6 December 2021

**Subject: Response to Comments Letter Dated November 17, 2021 from PGC
Engineering, PLLC
216 River Street Riverbank Stabilization Project
Haverhill, Massachusetts
Conservation Commission Filing #33-1515**

Figure 1. Previous design iteration of slope stabilization extending on 210 River Street.

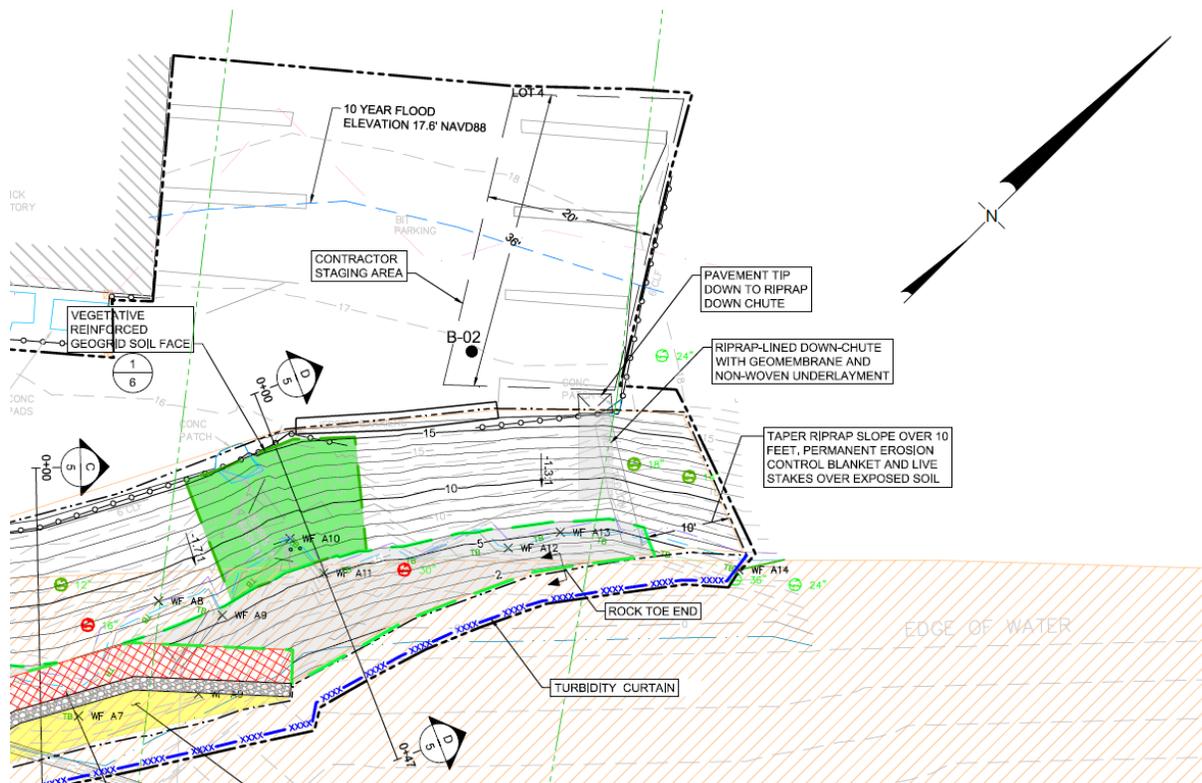
Comment #1: Permanence of proposed stabilization. We now question the permanence of the presently proposed stabilization without extension onto the property at 210 River Street. If that extension was once necessary to protect the integrity of the Bank Stabilization at 216 River Street why is it now not necessary?

The previous iteration of the design (prior to submission with the NOI) extended the stabilization approximately 10 to 15 feet onto the adjacent property at 210 River Street. The initial intent of extending the stabilization onto the adjacent parcel was primarily to replace an existing corrugated metal pipe chute that crosses the property line with a riprap lined downchute for stormwater management as well as flatten the existing riverbank slope in the vicinity of the property line (**Figure 1** below – note the approximate property line is represented by the green long dash, triple short dash line).

As shown on **Figure 1**, the proposed grades generally mimic the existing conditions on the majority of the grading on 210 River Street and is not necessary for the stabilization proposed on 216 River Street. After further observations of Site drainage during precipitation events, stormwater runoff from this portion of existing parking lot drains southerly toward the existing concrete blocks and onto the slope. Based on these observations, the proposed stormwater down chute was relocated to the south and there is no longer a need to replace the corrugate metal pipe which can be left in place. Therefore, there is no longer a need to extend the stabilization onto 210 River Street.

Figure 2: Detail symbology for plan set.

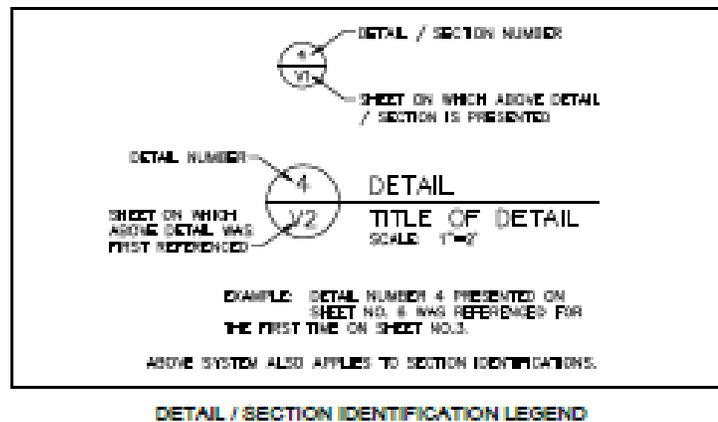
Comment: On sheet 6 of 8 of the submitted plans in both detail B/5 and D/5 the Vegetated Reinforced Geogrid is referred to as detail 1/6. There isn't any detail 1/6. It appears the proper reference should be 1/5.

Response: The detail call outs are explained on Drawing 1 of 8 as shown in Figure 2 below. Detail 1/6 is correct and represents detail 1 which is first referenced on Drawing 6.
